COUNCIL ASSESSMENT REPORT

Panel Reference	PPSSEC-199
DA Number	DA-177/2022
LGA	Waverley
Proposed Development	Demolition of existing buildings and construction of a nine-storey residential flat building containing 41 apartments, including 25 affordable rental housing apartments, communal roof top terrace and two levels of basement parking
Street Address	7-15 Bondi Road, BONDI JUNCTION
Applicant/Owner	Bondi Road Development P/L
Date of DA lodgement	5 May 2022
Total number of Submissions Number of Unique Objections	22 submissions
Recommendation	Approval
Regional Development Criteria (Schedule 6 of the SEPP (Planning Systems) 2021	Chapter 2: State and Regional Development Section 2.19(1) declares the proposal regionally significant development pursuant to Clause 5 (Private infrastructure and community facilities over \$5 million) of Schedule 6 as the proposal includes affordable housing with a Capital Investment Value of the development is \$9,588,967 (excluding GST).

Figure 9: Height plane diagram

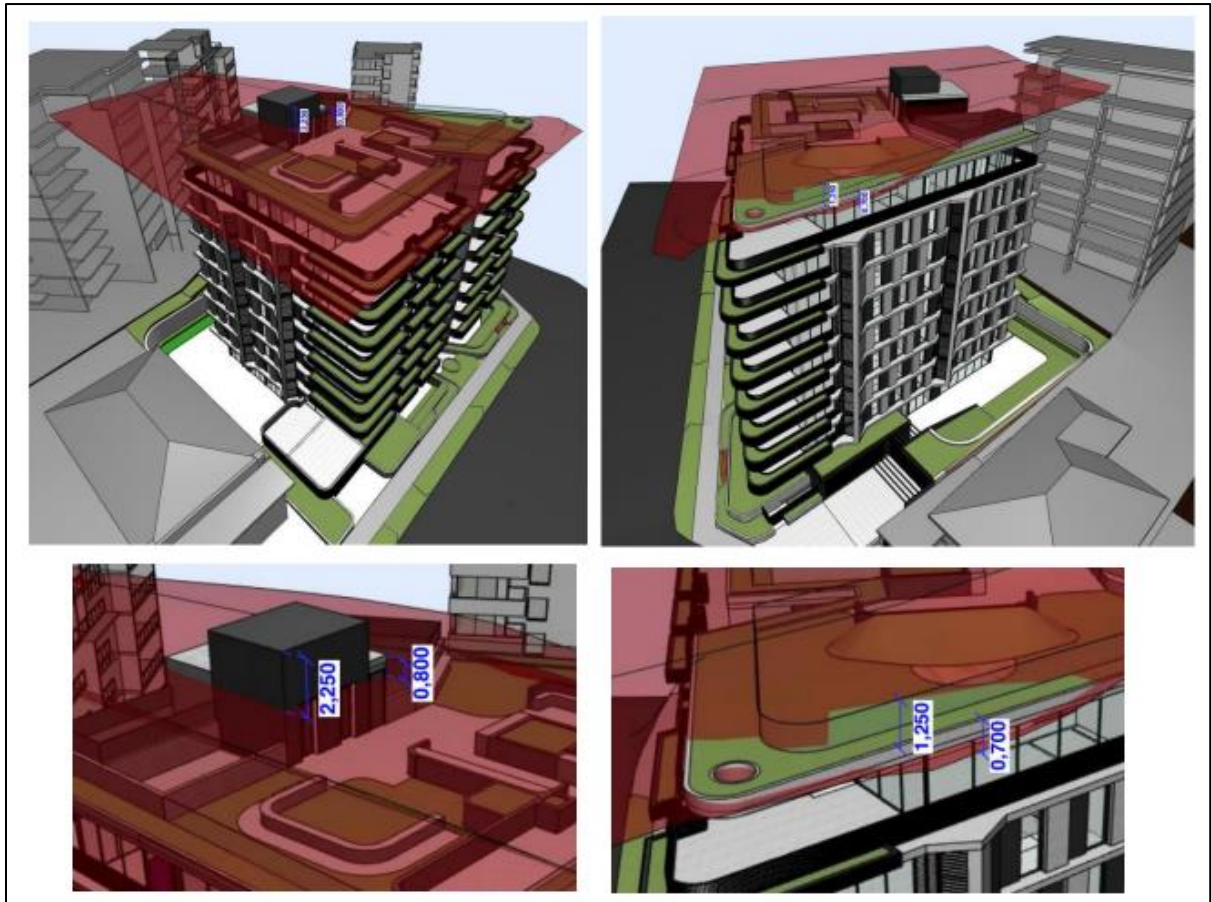
The following images provided by the Applicant demonstrate the extent of the height variation across the roof plane and indicates that only the north-western corner of the roof, the lift overrun and fire stair roof exceed the height development standard. The lift overrun exceeds the development standard by 2.25m or 8%, the fire stairs by 800mm or 2.8% and the north-western corner by 1.25m or 4.5%.

The majority of the proposed development is contained within the height development standard for the site. The exception to this is a small portion on the north-western (front) corner of the building and the roof plant in some sections.

The variations to the height development standard are located centrally on the roof to the rear and on the front north-eastern corner. The plant that exceeds the height will not be viewed from the street and are part of common roof plant and overruns that are synonymous with tower development in the Bondi Junction area. Further, the overall development is architecturally designed and comprises sufficient perimeter landscaping on the roof levels of the building, which will assist to soften the appearance of the lift overruns and circulation cores.

The other height non-compliance relates to the lift overrun and enclosure over the fire stairs. The plant is set back toward the rear of the building and will only be obscurely visible, if at all, within the streetscape. The area of non-compliance does not add unreasonably to the bulk and scale of the building given that it is set so far back from the front edge of the building.

Figure 10: Extract from shadow diagrams indicating the extent of the additional overshadowing as a

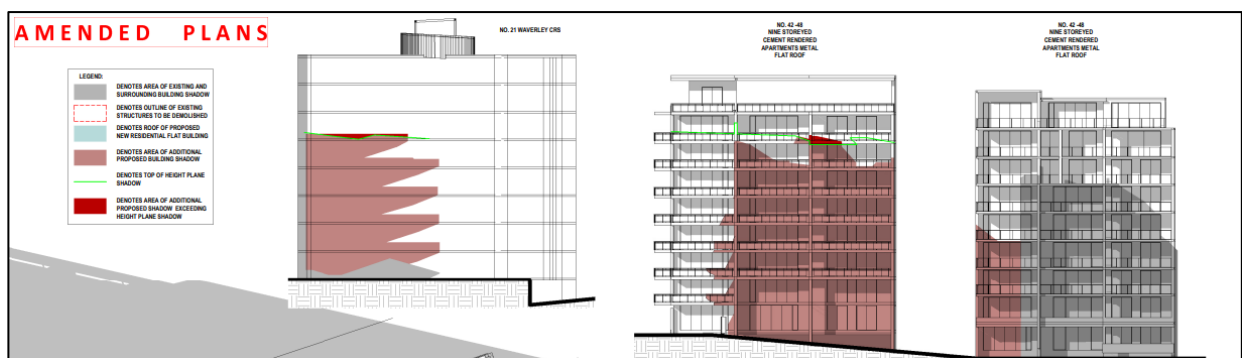
The amended proposal is accompanied by detailed shadow analysis in the form of ‘view from the sun’ and plan and elevational form shadow diagrams prepared in hourly increments between 9am and 3pm on 21 June. The plan and elevational shadow diagrams indicate a ‘permissible height compliant’ shadow, based on a development that would meet the height development standard across the entire built form (noting that the proposal does not achieve the maximum height development standard at the rear and only exceeds the height in small areas). The diagrams also distinguish parts of the overall shadowing of the development that may be specifically caused by the variations to the height of buildings development standard.

The shadow diagrams indicate that the variation to the height development standard will result in additional overshadowing (ie, that beyond a height compliant form) only at 9am. For the remainder of the day, the overshadowing caused by the height variation will fall within the overshadowing caused by that part of the building that complies with the height development standard. As demonstrated in **Figure 10** below, at 9am the additional overshadowing falls onto the side wall of 21 Waverley Crescent and over the balcony balustrade of two apartments at 42-48 Waverley Street at the rear.

Figure 11: Extract of the plans showing that the sightlines from the balconies at the uppermost level of the building at 42-48 Waverley Crescent is lower than the height development standard applicable to the site

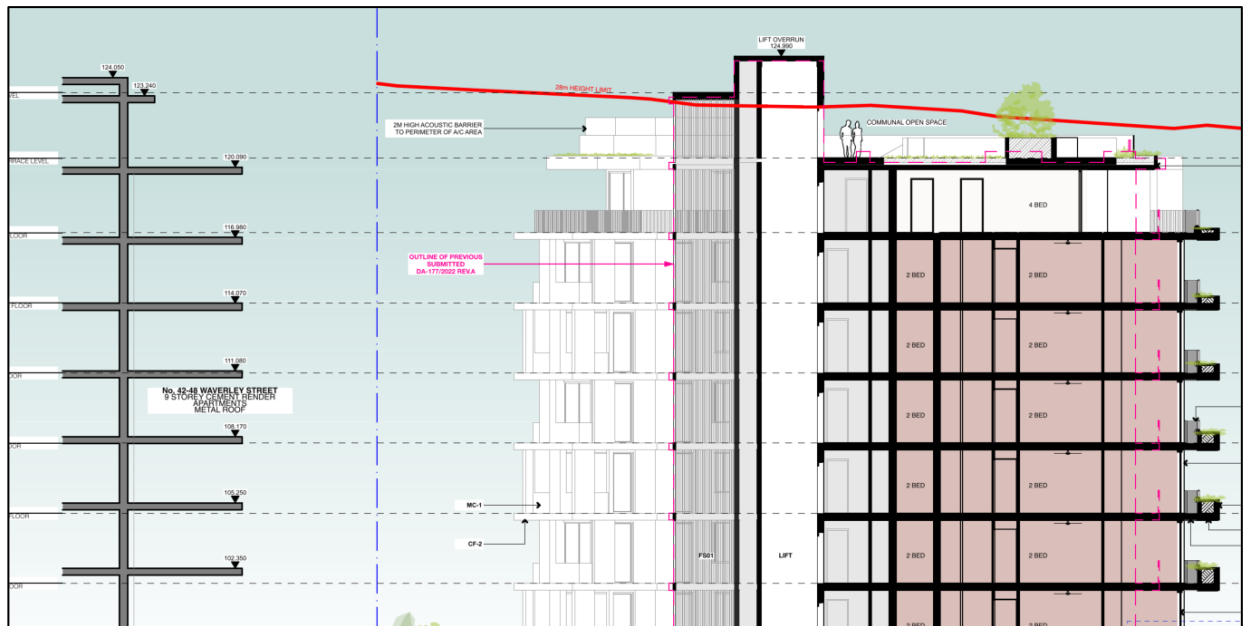
As detailed previously, where the proposal exceeds the maximum development standards, the impact of the variation is more heavily scrutinised particularly in relation to preserving the amenity of surrounding properties. That part of the building that exceeds the height development standard is confined to the roof area and the front corner of the building. As demonstrated by the section in **Figure 11** below, the variation to the height is contained above the sightlines from the residential flat building at the rear and therefore the variation has no greater impact upon views than a height compliant building would have.

The view impacts caused by the variations to the development standard are considered acceptable, and therefore, preserve the environmental amenity of neighbouring properties and surrounding public spaces.
